# **Proposed Timaru District Plan**

## **Section 42A Report: Designations**

**Report on submissions and further submissions**

**Date: 6 June 2025**

Figure 1 - Aerial photograph showing the previous and current location of the Cladeboye Exchange. Lot 4 DP 75226 is outlined in red. RS 38157 is outlined in yellow.

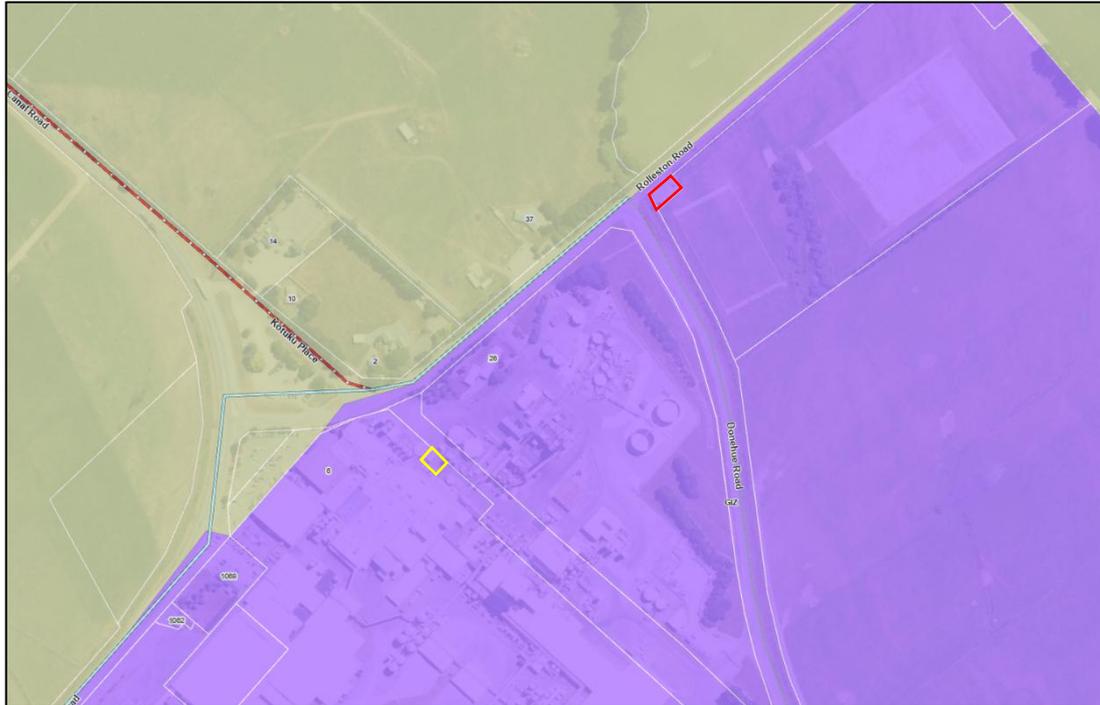
- 3.4.7 Designation 135, in the ODP, is identified as being located on land legally described as RS 38157. However, CNZ and SPK assets for the Clandeboye Exchange are located 300m away on land legally described Lot 4 DP 75226. An aerial photograph showing the location of RS 38157 and Lot 4 DP 75226 is displayed in Figure 1.

- 3.4.8 Lot 4 DP 75226 is located at the corner of Rolleston Road and Donehue Road and is zoned GIZ in the PDP (purple shading in Figure 1). The site is owned by CNZ and has a net area of approximately 422m<sup>2</sup>. The site is subject to the following overlays in the PDP:

Figure 4 - Aerial Photograph showing the location of the Hilton Exchange. The Hilton Exchange is outlined in red.

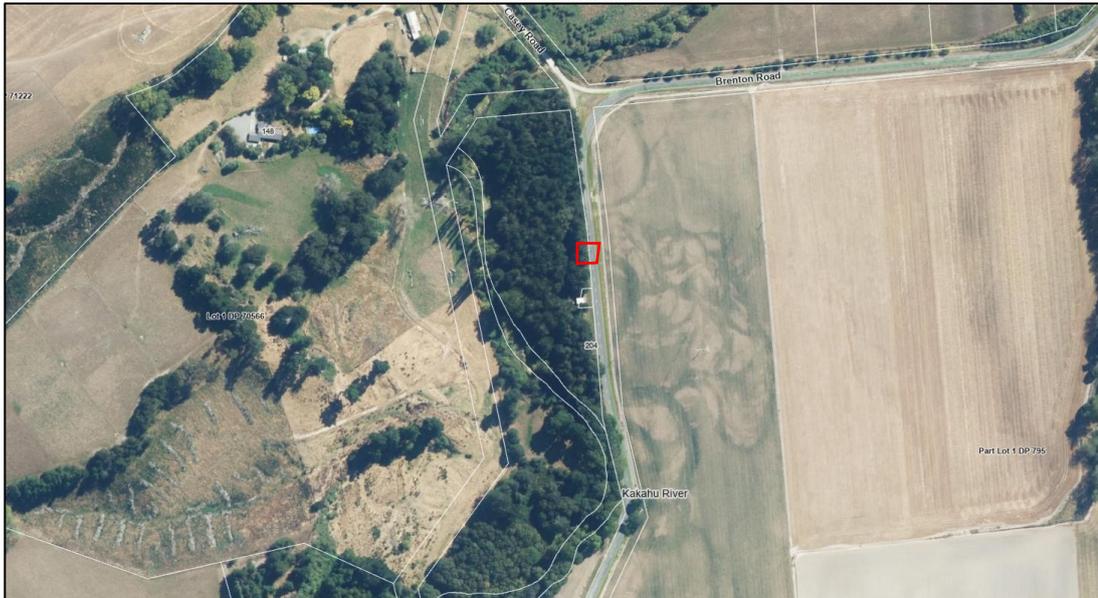
- 3.4.23 CNZ in their Clause 4 Notice seek a NOR for the Hilton Exchange located at Brenton Road, Hilton Geraldine. The NOR, as outlined in **Appendix 4**, is sought to allow the continued operation and maintenance of existing utilities at the site, to secure the site for its designated purpose, and to provide notice to the community of the intention of CNZ to use the site for telecommunication, radiocommunication and ancillary purposes. The site is legally described as Part Lot 1 DP 795 and is zoned GRUZ in the PDP. The site is subject to the Flood Assessment Area and Liquefaction Area overlays and is identified as LUC Class 3 land. The site is not listed on the Environment Canterbury Regional Council Listed Land Use Register.

- 3.4.24 The site is small in scale (approximately 207m<sup>2</sup>) and contains an existing building as displayed in Figure 3. The exterior of the building is white weather board with a small window. Access to the site is obtained via Brenton Road. There is no formed vehicle crossing to the site. The site is surrounded by rural production land and existing trees/vegetation. As detailed in the NOR, a range of equipment may be required at the site in future, including a new building for housing equipment, a mast or masts, antennas, on-site air-conditioning and on-site parking for technicians. The NOR does not include any immediate changes to the site and no conditions have been proposed as part of the NOR. An aerial image showing the location of the site is displayed in Figure 4.

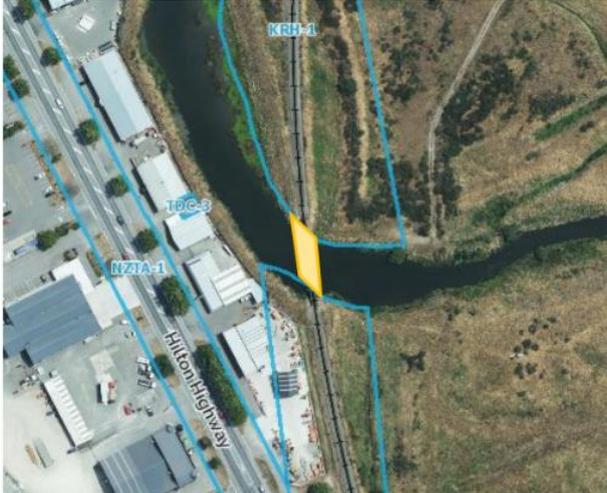
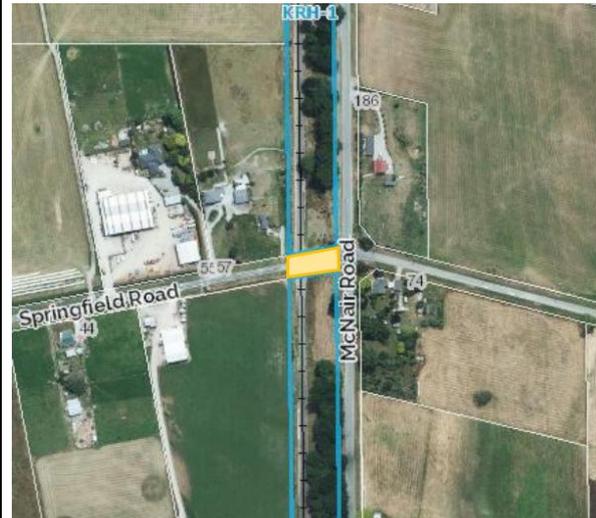
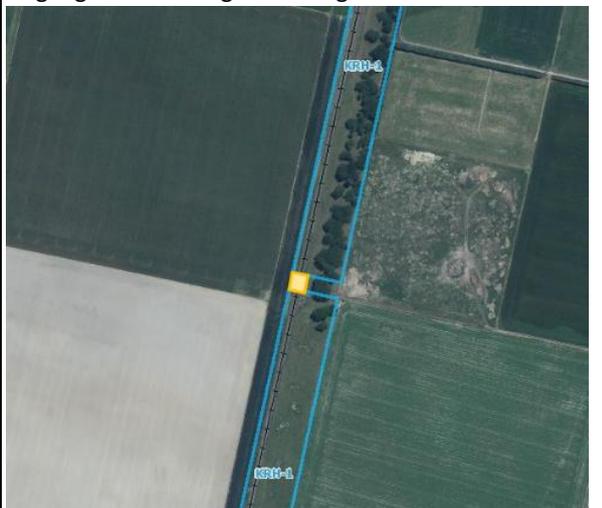
187.94	<p>KRH-1 includes the Orari River Bridge (Bridge 67, Main South Line). The area to be included is shaded in orange in the figure below:</p> 	<p>Inclusion of these bridges, in my view, is consistent with the outcomes sought in the PDP. TRAN-P3 seeks to enable the safe and efficient use of existing land transport infrastructure (including bridges) by providing for its operation, maintenance and upgrading.</p> <p>Maintenance and upgrading (including replacement) of existing land transport infrastructure is also a permitted activity in the PDP (TRAN-R1 and TRAN-R2).</p>

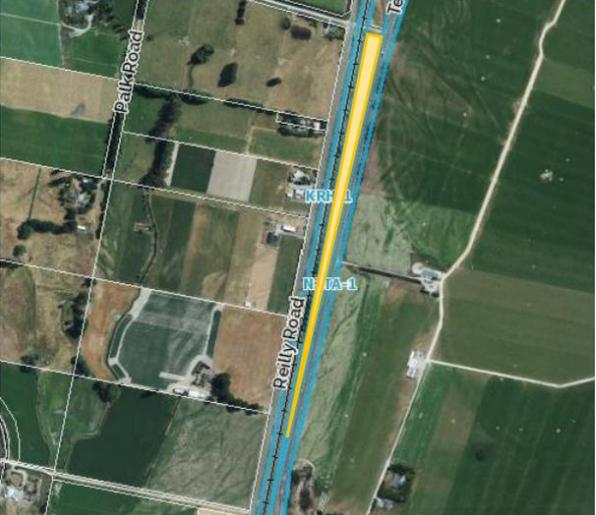
<p>187.102</p>	<p>KRH-1 includes the Washdyke Creek Bridge (Bridge 79, Main South Line). The area to be included is shaded in orange in the figure below:</p> 	<p>In my opinion, inclusion of these bridges is reasonably necessary to achieve the objectives of the requiring authority by providing certainty for the future operation, maintenance, use and improvement of these bridges for railway purposes.</p> <p>I therefore recommended that the submission points from KiwiRail [187.91, 187.94 and 187.102] be accepted in part and that the full extent of the Rangitata Bridge, the Orari River Bridge and the Washdyke Creek Bridge are included in KRH-1 as set out in <b>Appendix 1</b>.</p>
----------------	--	---

Figure 5 - Aerial photograph of MEDU-6 and MEDU-7. The designation boundaries of these schools are outlined in blue. Part Lot 32 DP 2069, Part Lot 1 DP 2365 and Lot 7 DP 241 within MEDU-7 are outlined in red.

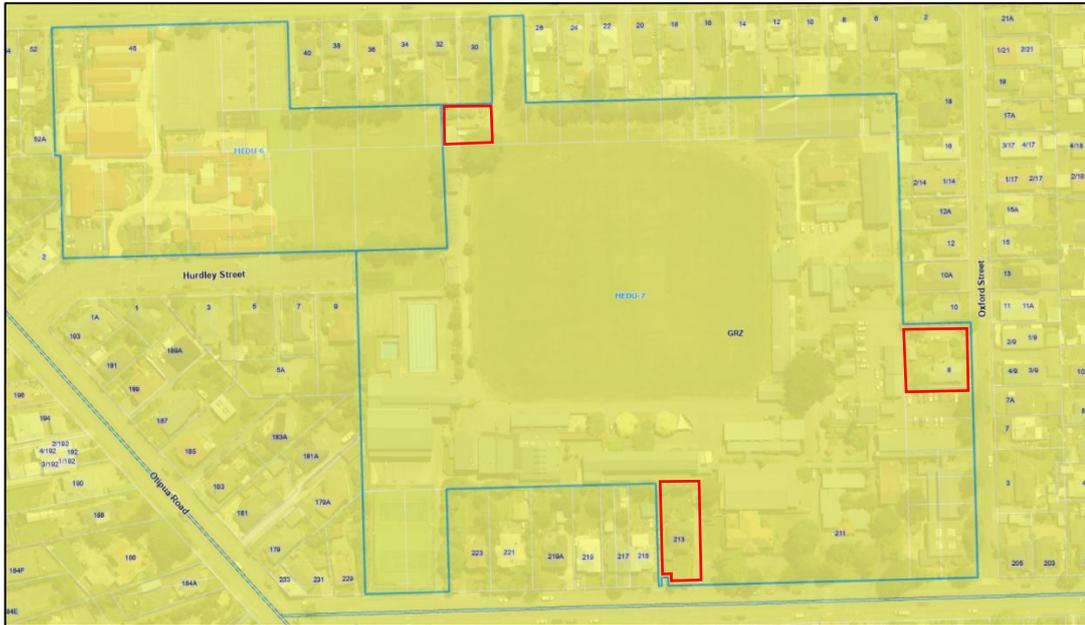
- 3.6.10 I do not support MoE proposed mapping change to MEDU-6 [106.58] and MEDU-7 [106.60]. To my understanding, the PDP maps already identify Part Lot 32 DP 2069, Part Lot 1 DP 2365 and Lot 7 DP 241 as being part of MEDU-7 (in accordance with MoE submission) as displayed in Figure 5 (the designation boundaries are outlined in blue). I note that when you click on

3.6.11 Subject to new shapefiles being provided (or revised maps that clearly show the dimensions of the areas to be excluded) I am comfortable with MoE proposed mapping changes to MEDU-26 [106.81] and MEDU-27 [106.83]. In my view, the proposed mapping changes

Figure 6 - Aerial photograph of MEDU-6 and MEDU-7. The black and white dashed line shows the property boundaries of MEDU-27 based on cadastral boundaries.

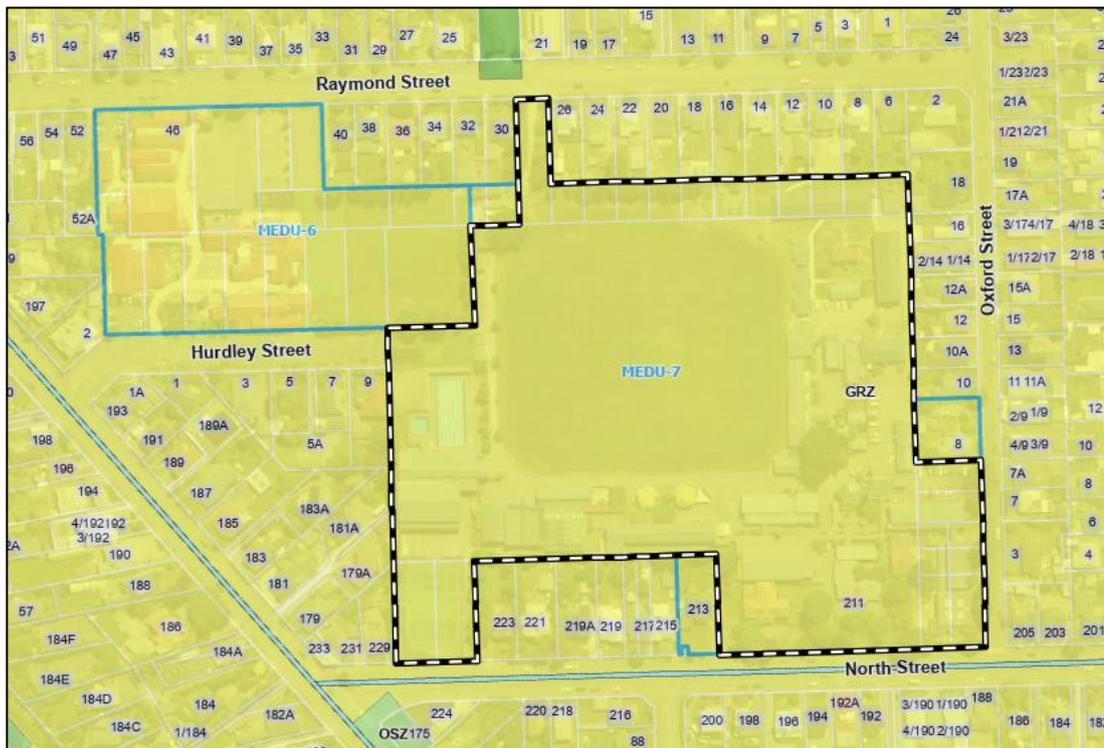
MEDU-6 and MEDU-7, the black and white lines show the property boundaries of the sites (based on cadastral boundaries) and do not identify the designation boundaries (as displayed in Figure 6).
